**RE: 4525 Quaker Heights PI NW
Grading and Drainage Plan
Engineer's Stamp Date: 02/26/26
Hydrology File: F11D020B
Case # HYDR-2026-00073**

Based upon the information provided in your submittal received 02/26/2025, the Grading and Drainage Plan **is not approved** for Grading Permit and Building Permit. The following comments need to be addressed for approval of the above referenced project.

GD2

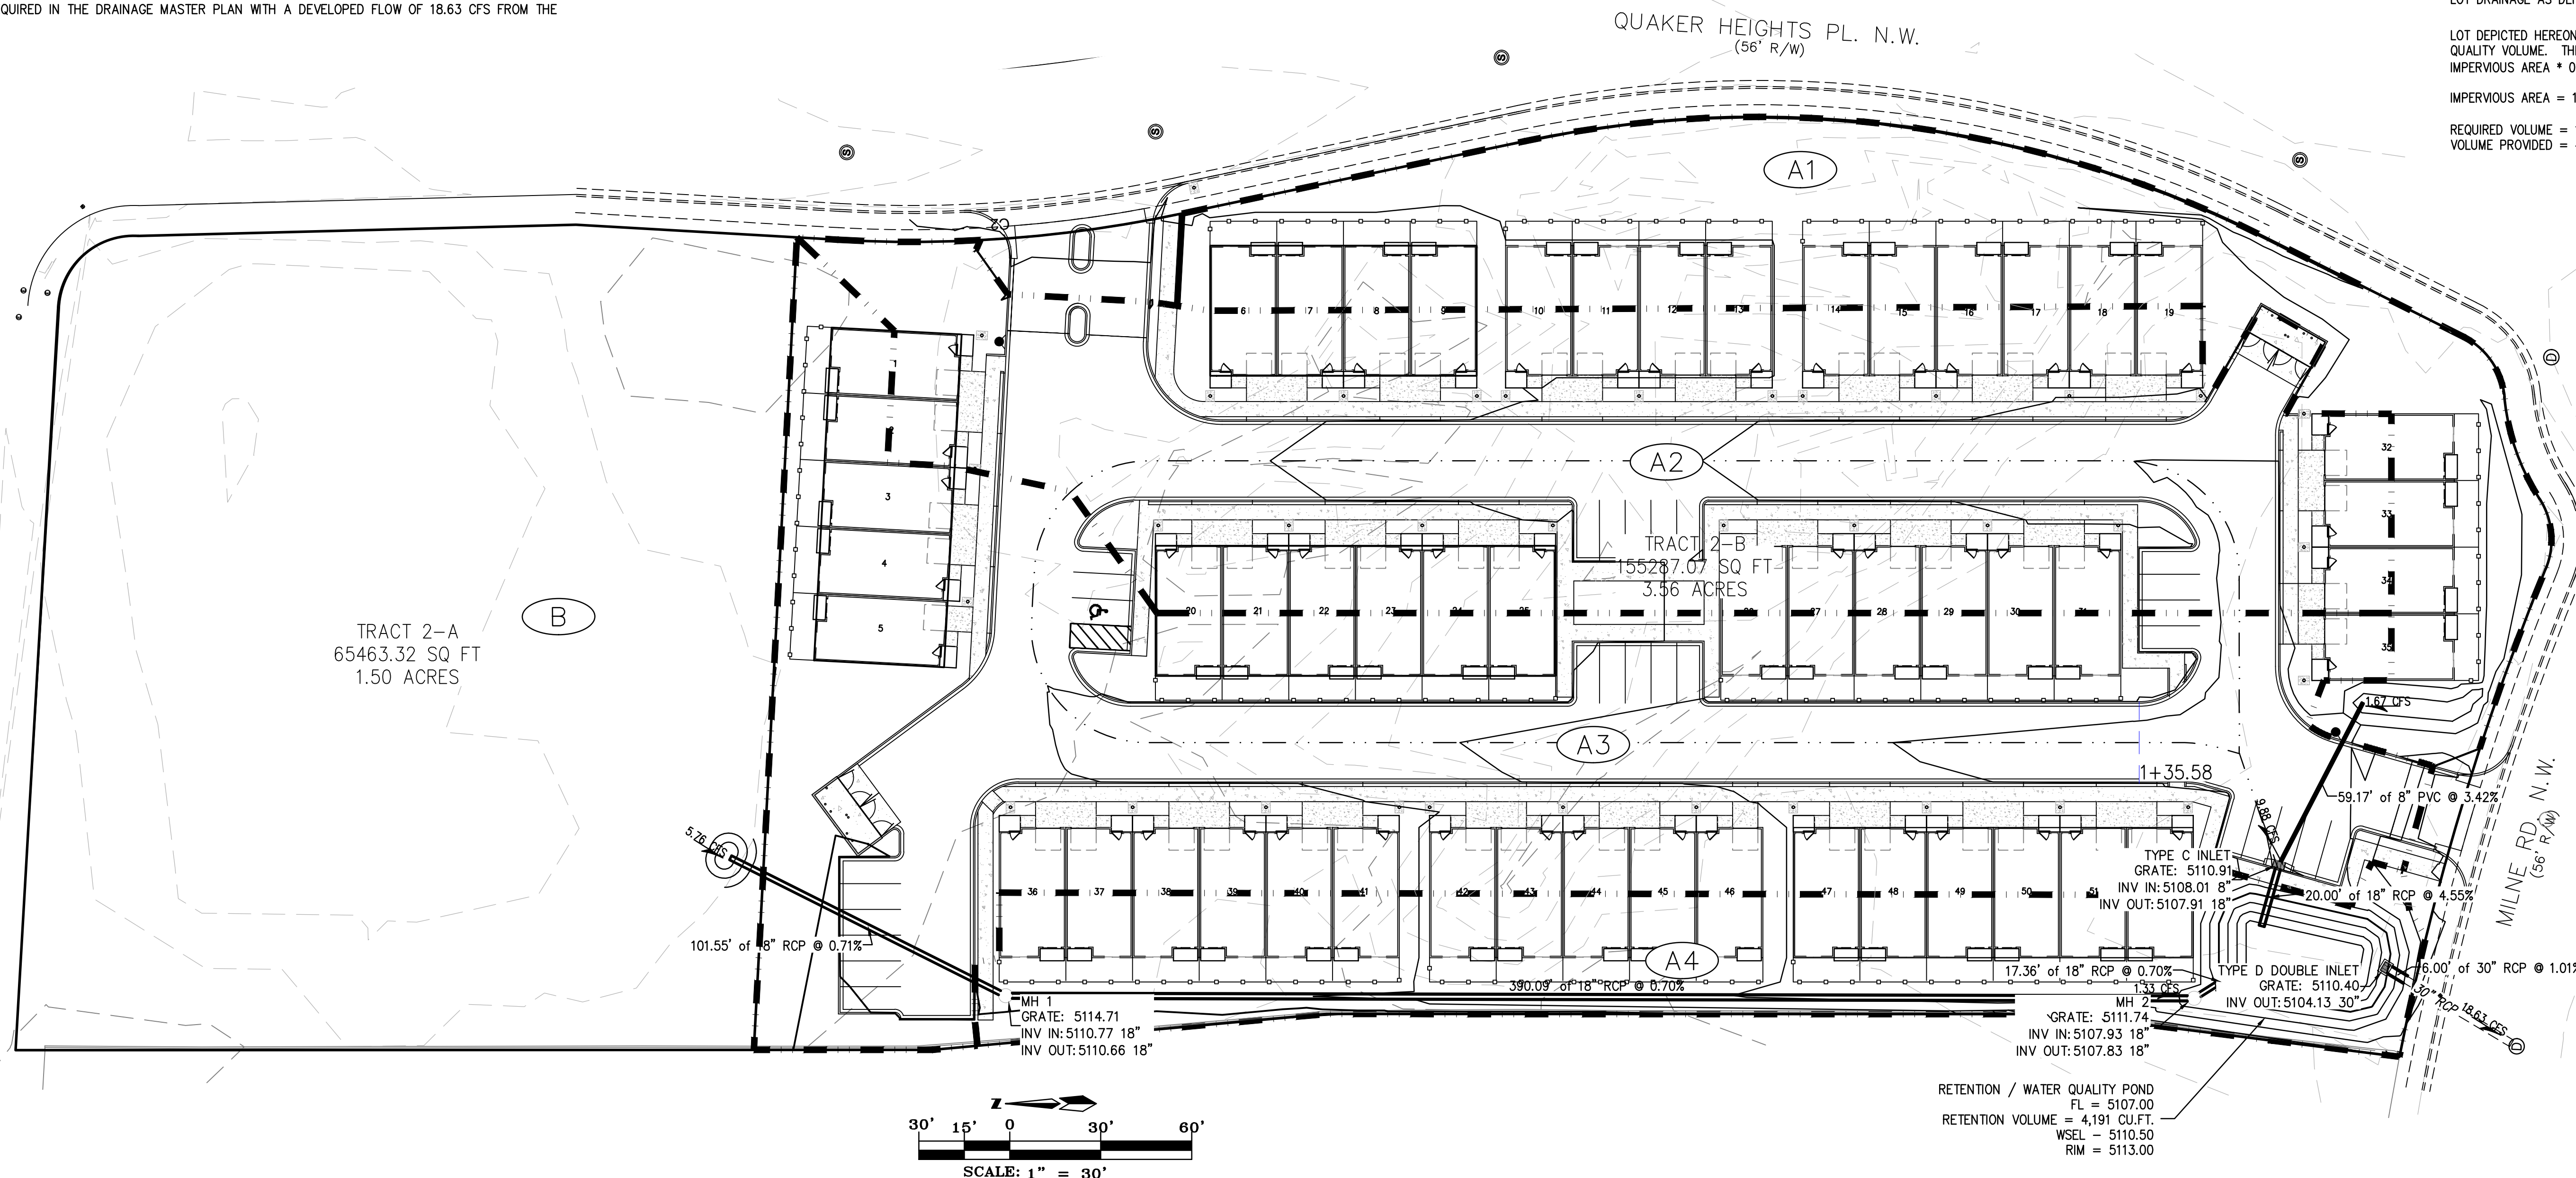
1. Please provide the FIRM Map floodplain note with effective date.
2. Please provide the legal description of the property.
3. Please show Finished Pad Elevations in addition to Finished Floor Elevations for all structures.
